# Land Use Committee Report

## City of Newton In City Council

**Thursday, March 5, 2020**

**#26-20**      **Request to Rezone Approximately 4.4 acres to MU-3 to Create a Contiguous MU-3 Zone**  
MD 399 GROVE OWNER, LLC/RAMIREZ CONCORD, LLC/BH NORMANDY RIVERSIDE, LLC/MASSACHUSETTS BAY TRANSPORTATION AUTHORITY petition for a change of zone to Mixed Use 3/Transit Oriented District for portions of land located at 355 Grove Street (currently zoned BU-2) and 399 Grove Street (currently zoned BU-5), also identified as Section 42, Block 11, Lots 3, 4, and 4A, abutting the existing MU-3 Zone.

Figure 7.3.1  
Proposed Green Infrastructure

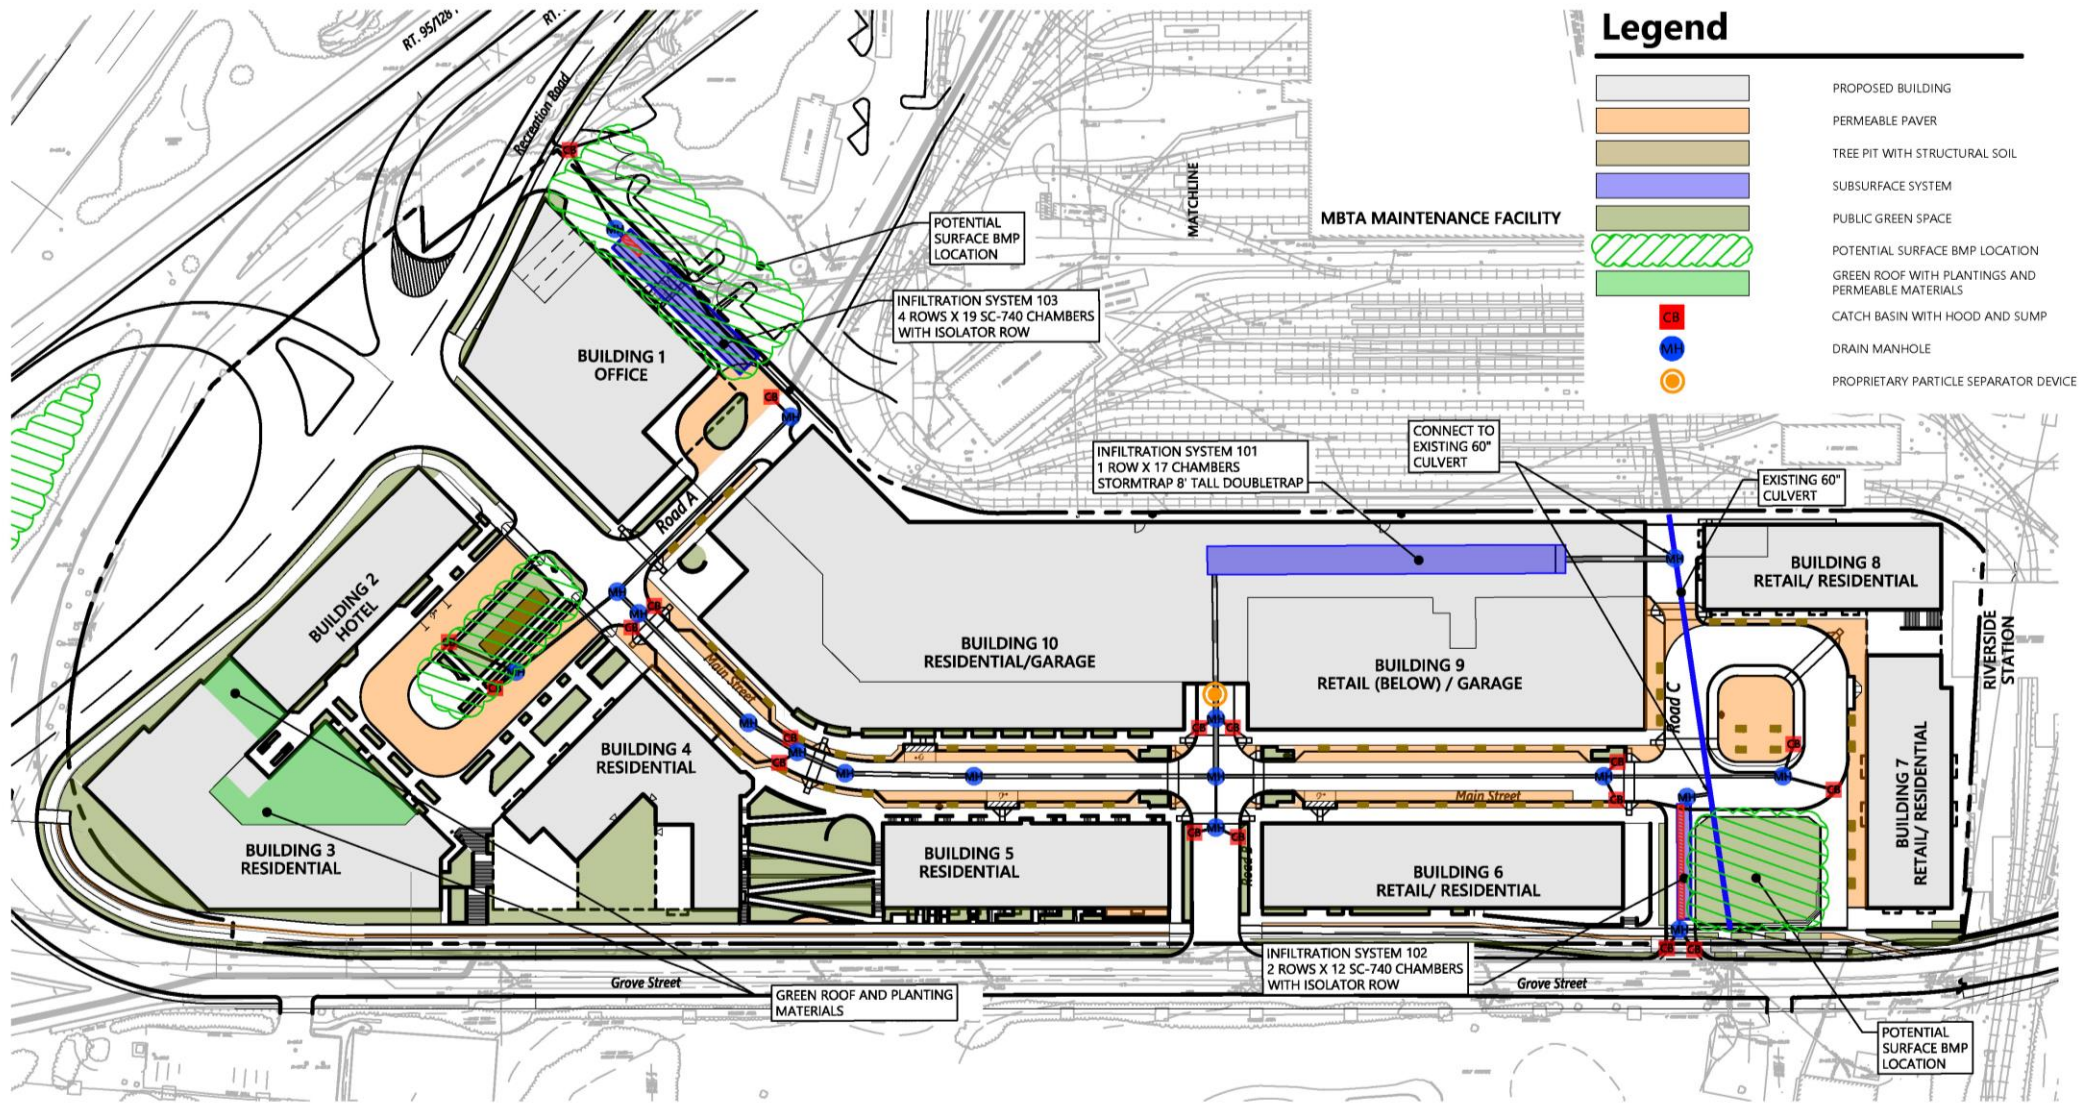
1. The proposed drainage design approach appears to meet regulatory goals.
2. Three proposed infiltration systems provide flow and volume reductions.
3. Proposed phosphorus loading reduction is 85% (TMDL target is 65%).
4. The proposed green infrastructure concept is consistent with MassDEP principles and the City's Street Design Guide.
5. More information is needed to verify the design and regulatory compliance.

1. Updated design plans and calculations including revisions and clarifications addressing March 3 memorandum comments.
2. Additional detail regarding proposed green infrastructure practices.
3. Clarification of “Southern Yard” drainage.
4. Inspection of the existing 60-inch culvert (before and after construction).
5. Additional soil testing to verify infiltration assumptions (at time of construction).
